Mr James Appleton: case officer AWDM/0961/17  
Adur and Worthing District Councils  
Development Management  
Portland House  
44 Richmond Road  
Worthing, West Sussex  
BN11 1HS

13 September, 2018

**Objection to New Monks Farm planning application (AWDM/0961/17)**

## Appendix 6 - Diversions and time delays

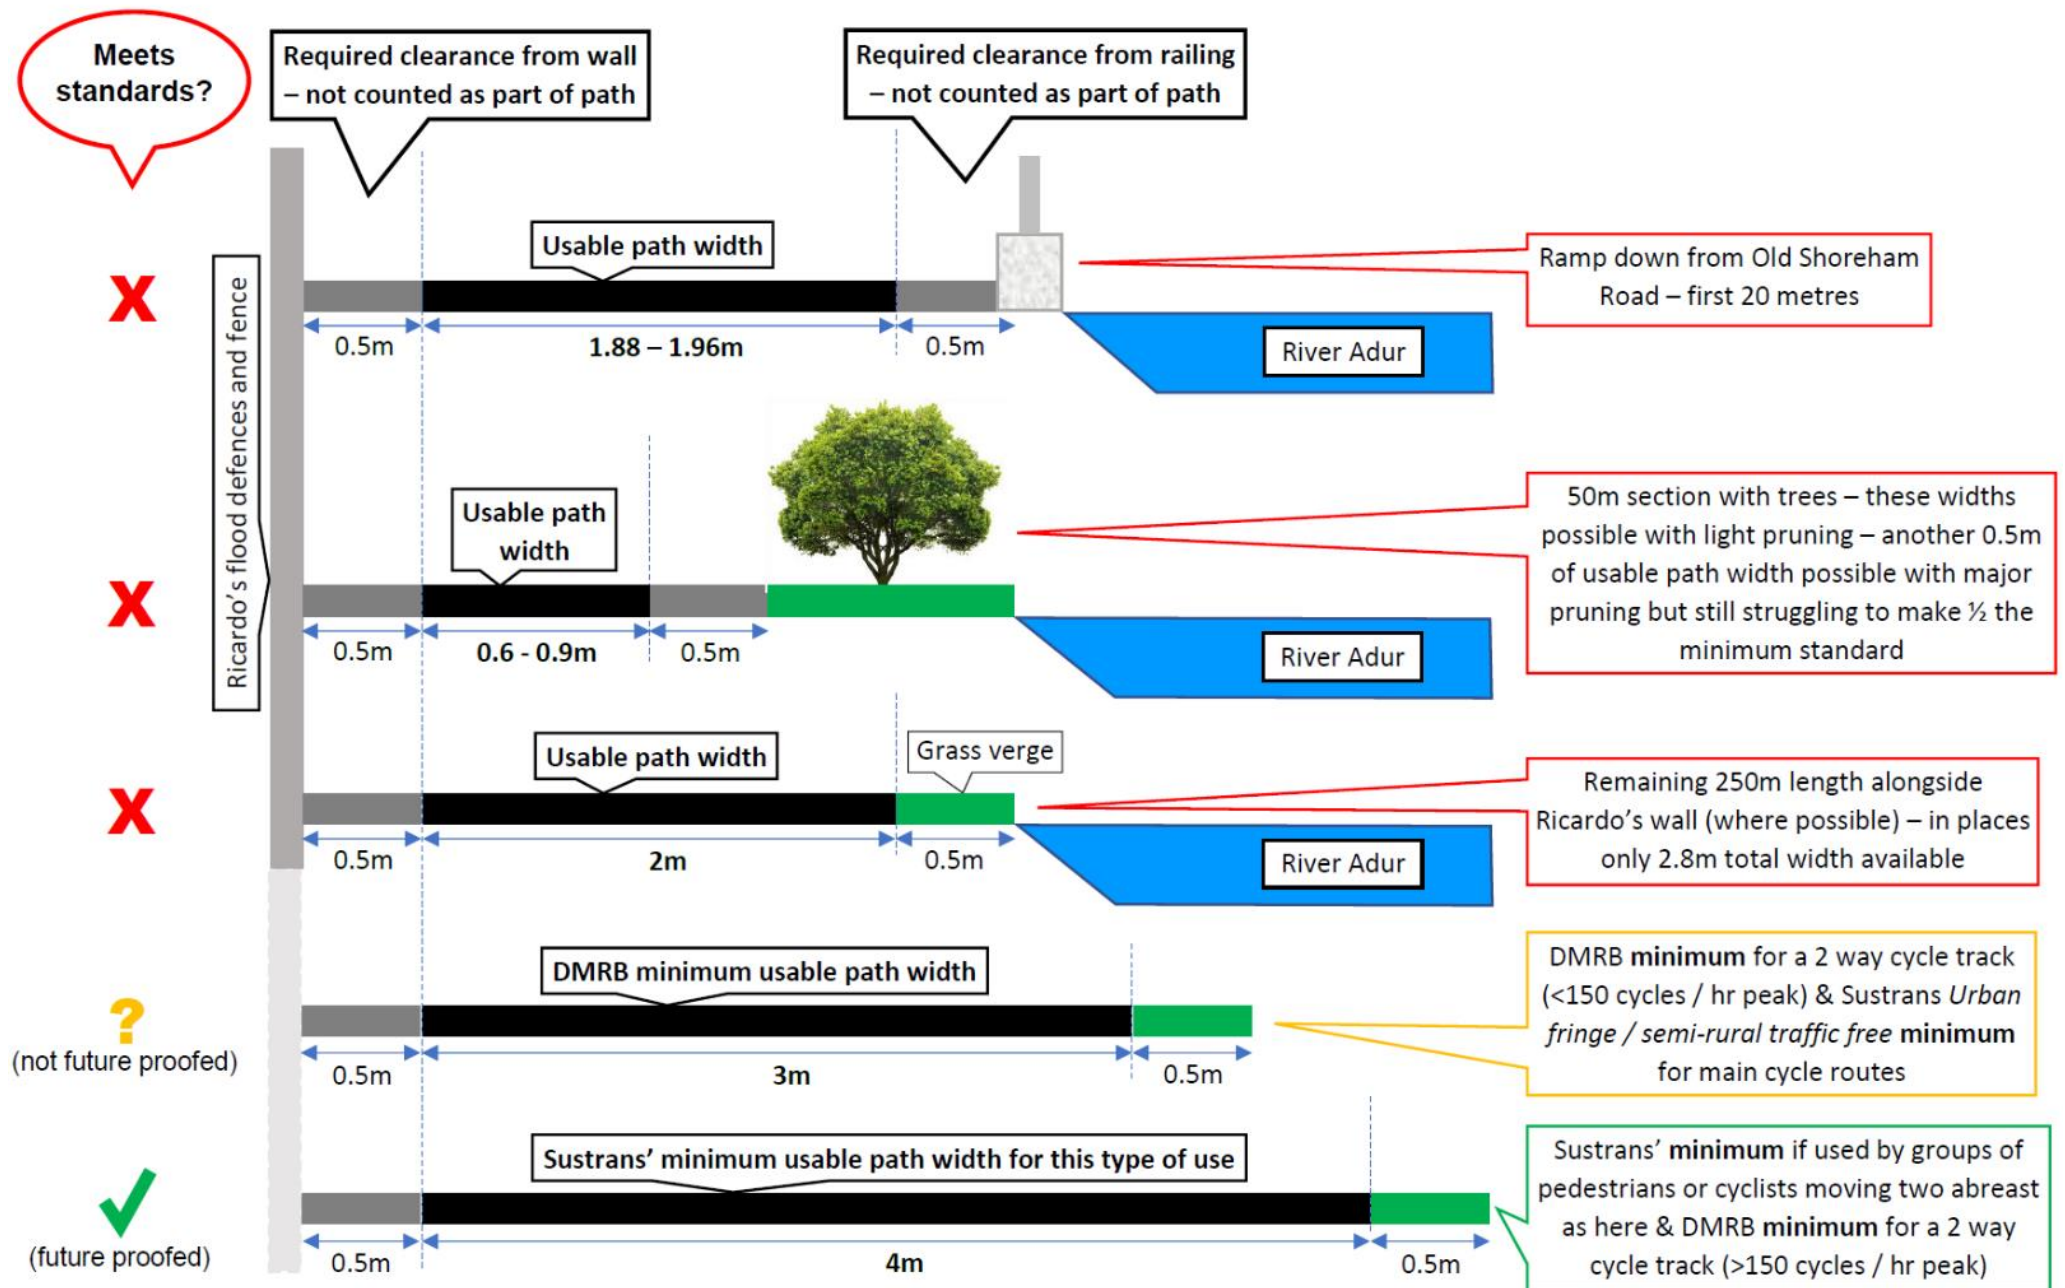
\* It is unlikely cyclists would travel at 12mph on the new bridleway as there is a 90 degree tight turn onto it with bollards, its narrowness, tight bends plus other users, all of which would slow them down. They may also have to wait to join Coombes Road. Therefore, times are given for cycling at 8mph (the more realistic speed in this situation) as well as 12 mph (used by the consultants). More cautious and less confident cyclists would travel even slower than this.

\*\* Calculated at 8mph as with all the stop – starts and tight bends unlikely cyclists could develop much speed here.
